HORSHAM DISTRICT COUNCIL CONSULTATION

TO:	Horsham District Council – Planning Dept
LOCATION:	Land to the South of Broadbridge Way Broadbridge Heath
DESCRIPTION:	Full Planning Application for the erection of 89no. residential dwellings comprising dwellings (54no.) and apartments (35no.), 36% affordable homes, creation of new vehicular access on to Sergeant Way, provision of public open space, landscaping and drainage solutions
REFERENCE:	DC/25/0894
RECOMMENDATION:	Holding objection / modification
RECOMMENDATION: 2nd Response in Red	Objection maintained, as modification is still needed to address Root Protection Area conflicts and concerns.
RECOMMENDATION: 3rd response in green	Advice / Holding objection withdrawn
RECOMMENDATION: 4th response in orange	Advice
SUMMARY OF COMMENTS & RECOMMENDATION: The submitted Arboricultural method statement and Tree protection plan are a fair assessment of the tree-related impacts of the development proposals at the site. However, some modification to the site layout is needed to address Root Protection Area conflicts and likely future resident pressure due to poor tree-to-build relationships post-development.

PROPOSED SITE LAYOUT showing the carpark to the north of T31 & T19

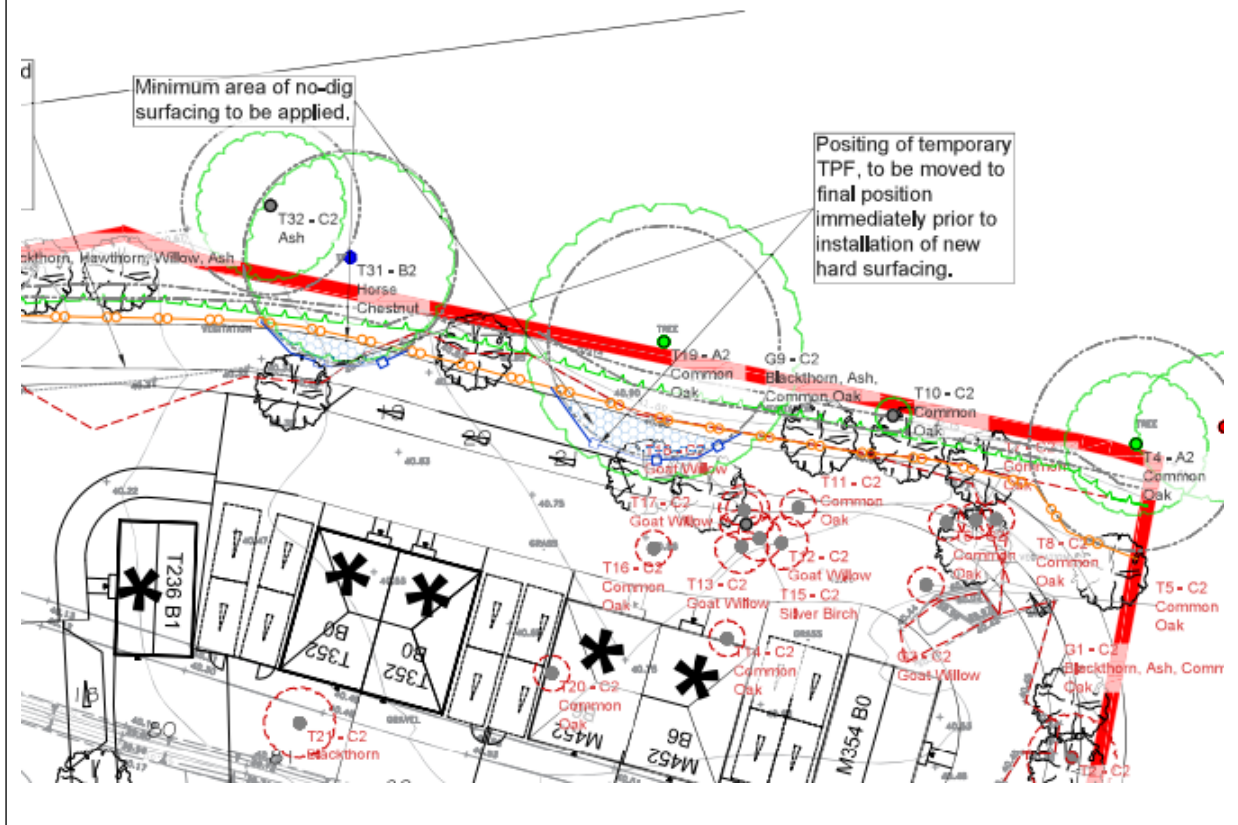
The Root Protection Areas (RPAs) for trees T31, T19, and T34 are still not considered to be plotted in accordance with BS5837:2012 (Section 4.6.2). whereby, existing off-site hardstanding within the northern portions of the RPAs of T31 and T19, and to the east of T34 where the RPA extends beneath Old Whickhurst Lane, has not been considered, offset, or modified to reflect the likely asymmetric rooting environment created by these constraints.

BS5837:2012 requires that where existing obstacles or surfaces constrain root development, the RPA should be amended to show where roots are most likely to occur. In this case, the off-site car park to the north of T31 and T19, which is clearly visible on the indicative site plan, has been omitted from the Tree Protection Plan. This results in a misleading representation of the trees' functional rooting environment and raises concern as to why this constraint has not been factored into the arboricultural assessment, particularly as it was raised in my previous response.

For both T31 and T19, nearly half of the theoretical RPA is currently shown extending beneath an impermeable car park surface to the north. This means that any additional encroachment into the remaining functional (southern) portion of the RPA becomes significantly more critical. As such, based on the current assessment the proposed cycle path, to the south of the trees, in particular, would in my opinion, increase development within the RPA as is currently shown well beyond the 20% threshold generally accepted within BS5837, further exacerbating non-compliance with the BS.

Tree Protection Plan DWG NO: VYH24657-03A Sheet 2 of 2. It should be noted that the date on the new TPP has not been updated from the 17/04/2025 submission, despite the plans and site layout having been altered.

Given the likely southward rooting bias for T31 and T19, caused by the existing hardstanding, the proposed new road to the south is expected to lie partially or wholly within the functional RPAs of T31 and T34. No mitigation measures have been proposed to address this conflict. As such, the scheme is not considered to be compliant with BS5837 and is likely to result in significant, delayed-onset harm to these trees over the next 5–10 years, due to construction activity and root loss/damage within their key rooting areas, unless the layout is amended accordingly.

The removal of the cycle route from the RPAs of trees T31 and T19, coupled with the amendments to the RPAs and the larger area covered by the TPF, is welcome. Subject to the works in the more sensitive areas being completed in accordance with the Arboricultural Method Statement, this should ensure that the retention of trees T31 and T19 is viable in the long term.
